#### **Project: IEEE P802.15 Study Group for Wireless Personal Area Networks (WPANs)**

**Submission Title:** PSSS proposal – Parallel reuse of 2.4 GHz PHY for the sub-1-GHz bands

**Re:** PSSS mode for more even chiprates, simpler filter, and 250 kbit/s in 868 MHz and new less

**Purpose:** Response to ballot comments to discuss potential modification of PSSS draft specification

PSSS 250-400 868 MHz – BPSK/ASK (20/32 bit/s/Hz)

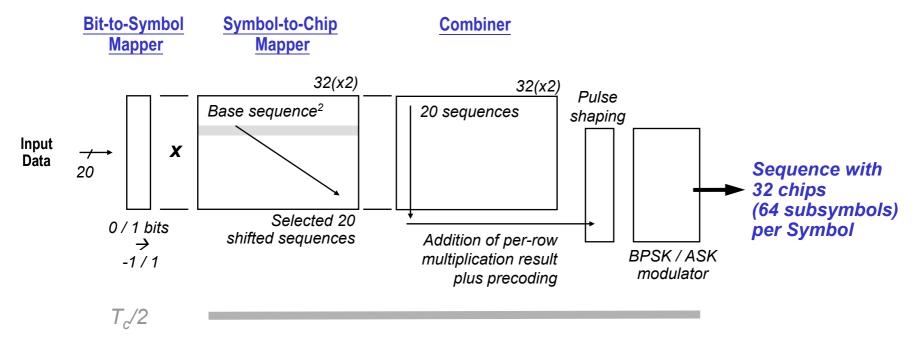
### No modification of the basic PSSS model:

- No increase of Tx complexity in real-world implementation
  - Oversampling used for baseband filtering to achieve PSD compliance anyhow
  - No change in number of chips per symbol no increase in coding table sizes
- Simpler baseband filter sufficient due to lower chiprate, see PSD at Appendix.
- No change in Rx processing required
- Similar performance, see Appendix.

## PER Performance PSSS 250-400 868 MHz (BPSK/ASK) – Discrete Exponential Channel, 250ns RMS Delay Spread

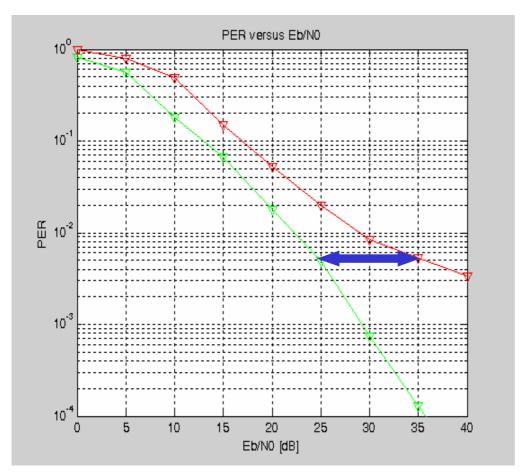
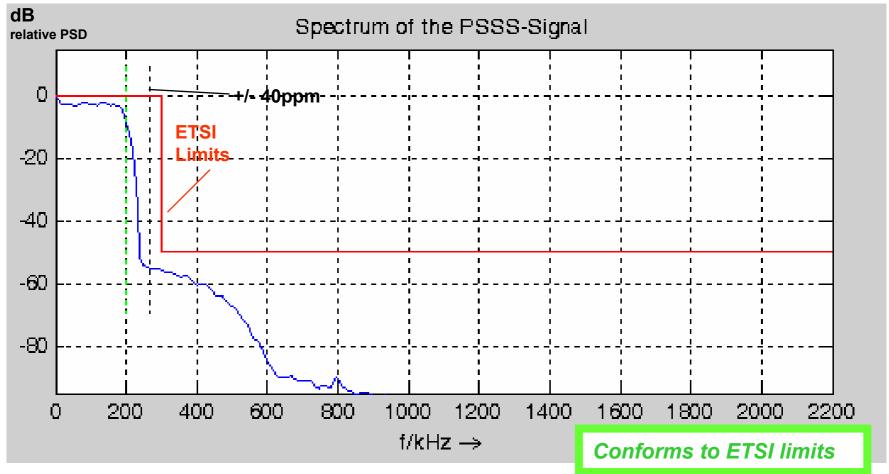
No visible degradation of performance

#### Preamble Detection with current Barker Code

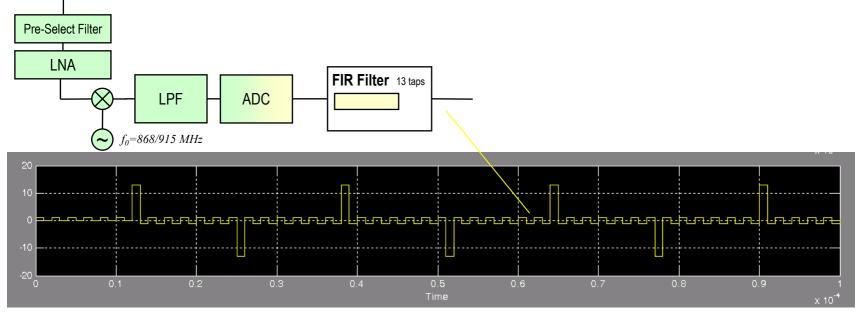
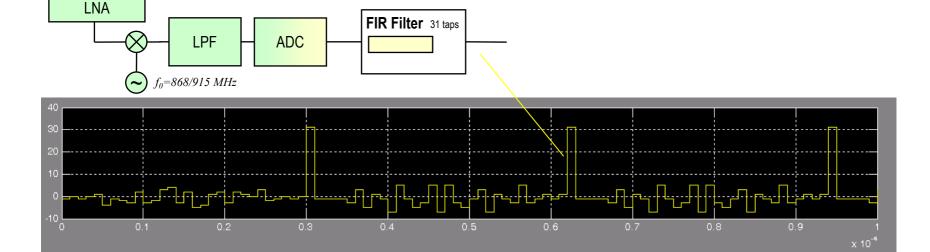
### Comparision Actual/New Proposed Preamble Length of Proposed Preamble

• The Sequence 0 is repeated 4/16 times for 868/915 MHz. Same duration of 320µs for both preambles.

- When detecting the current barker code based preamble with FIR filter, the signal coming out of the FIR filter has side slopes limited to +/- 1.
- Advantages:
  - DC free
- Disadvantages:
  - Two FIR filters needed, one for preamble detection (13 chip barker code), one for PSSS decoding (31 chip m-sequence).
  - Not multiple of symbol duration

- When detecting the preamble, base on repeated sequence 0 with FIR filter, the signal coming out of the FIR filter has side slopes limited to +5/-6.
- Advantages:
  - Use of just one FIR filter or correlator for preamble detection and PSSS decoding.
  - 32 chip long preamble code.= multiple of symbol duration and similar to other phys.
  - DC free

## PSSS Codes form Coding Table in Draft Standard For Preamble We propose to use Sequence $0 = c_0$ , 4/16 times repeated for 868/915 MHz, instead of the

- We propose to use PSSS 250-400 instead of PSSS 206-440 for ETSI.
- We propose also to use the new preamble base on Sequence  $C_0$  for similar design compared to the other Phys.
